Project	IEEE 802.16 Broadband Wireless Access Working Group < http://ieee802.org/16 >	
Title	Improved Space-Time Codes for the OFDMA PHY with four transmission antennas	
Date Submitted	2004-08-31	
Source(s)	<p>Seung Hoon Nam, Chan-Soo Hwang, Young-Ho Jung, Jaehak Chung, Yungsoo Kim Samsung Advanced Institute of Technology</p> <p>Erik Lindskog, V. Shashidhar, B. Sundar Rajan, Djordje Tajkovic, Tareq Al Naffouri, Erik Stauffer, Taiwen Tang, David Garrett, K. Giridhar, Bob Lorenz, Babu Mandava, A. Paulraj, Trevor Pearman, Kamlesh Rath, Aditya Agrawal, Mai Vu Beceem Communications, Inc.</p> <p>Chan Byoung Chae, Wonil Roh, Hongsil Jeong, JeongTae Oh, Kyunbyoung Ko, Sung Ryul Yun, Seungjoo Maeng, Panyuh Joo, Jaeho Jeon, Jaeyeol Kim, Soonyoung Yoon Samsung Electronics Co., Ltd.</p>	<p>seunghoon.nam@samsung.com Voice: +82-31-280-8196</p>
Re:	Contribution supporting TGe WG ballot #14c	
Abstract	Improved full-rate full-diversity space-time code for 4-Tx antennas

An Improved Space-Time Code for 4-Tx antennas

8.4.8.3.4. Transmission schemes for 4-antenna BS

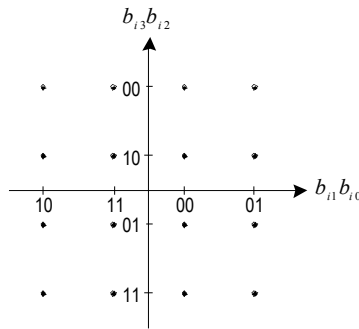
[Replace matrix A in the section 8.4.8.3.3 (p.164) and the following sentence with the following]

Replace the existing transmission matrix A:

With A_1 shown below:

where the complex symbols to be transmitted are x_1, x_2, x_3, x_4 , which take values from a square QAM constellation and $s_i = x_i e^{j\theta}$ for $i=1,2,3,4$, where $\theta = \tan^{-1}(2)$ for QPSK, $\theta = \tan^{-1}(1/4)$ for 16QAM, and $\theta = \tan^{-1}(1/8)$ for 64 QAM and let

$$A_1 = \begin{bmatrix} \bar{s}_1 & -\bar{s}_2^* & 0 & 0 \\ \bar{s}_2 & \bar{s}_1^* & 0 & 0 \\ 0 & 0 & \bar{s}_3 & -\bar{s}_4^* \\ 0 & 0 & \bar{s}_4 & \bar{s}_3^* \end{bmatrix} .$$

$$\bar{s}_1 = s_{1I} + js_{3Q} ; \bar{s}_2 = s_{2I} + js_{4Q} ; \bar{s}_3 = s_{3I} + js_{1Q} ; \bar{s}_4 = s_{4I} + js_{2Q} \quad \text{where } s_i = s_{iI} + js_{iQ} .$$

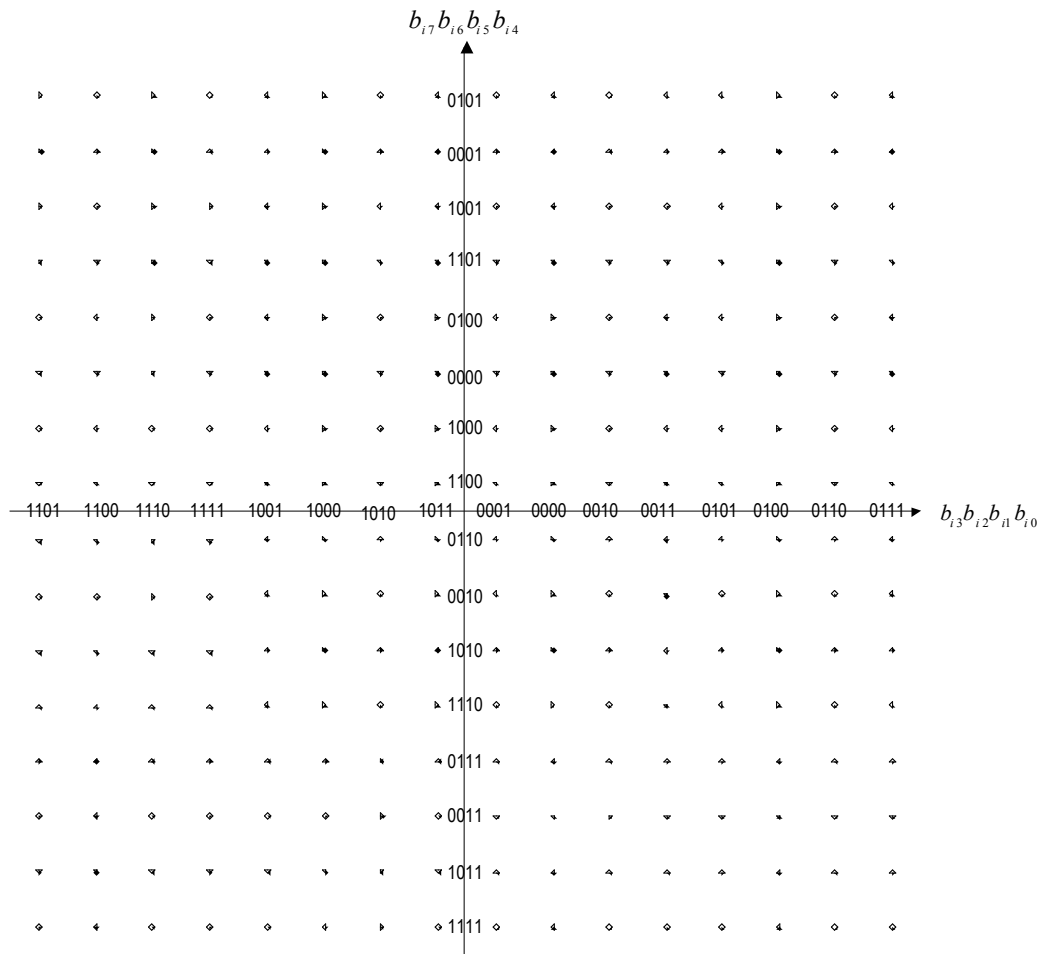
and for 16QAM ($B=4$)

Equivalently, \bar{s}_i can be obtained by the direct bit mapping defined as

$$\bar{s}_i = m(\mathbf{b}_i) .$$

where $\mathbf{b}_1 = [\mathbf{u}_1^T \mathbf{u}_3^T]^T$, $\mathbf{b}_2 = [\mathbf{u}_2^T \mathbf{u}_4^T]^T$, $\mathbf{b}_3 = [\mathbf{u}_3^T \mathbf{u}_1^T]^T$, $\mathbf{b}_4 = [\mathbf{u}_4^T \mathbf{u}_2^T]^T$, $\mathbf{u}_1 = [u_{10} \ u_{11} \ \dots \ u_{1B-1}]^T$, $\mathbf{u}_2 = [u_{20} \ u_{21} \ \dots \ u_{2B-1}]^T$, $\mathbf{u}_3 = [u_{30} \ u_{31} \ \dots \ u_{3B-1}]^T$, $\mathbf{u}_4 = [u_{40} \ u_{41} \ \dots \ u_{4B-1}]^T$. B denotes the number of bits to be transmitted within a symbol duration ($B=2, 4, 6$). $m(\cdot)$ denotes the square QAM modulation function whose input and output are defined as
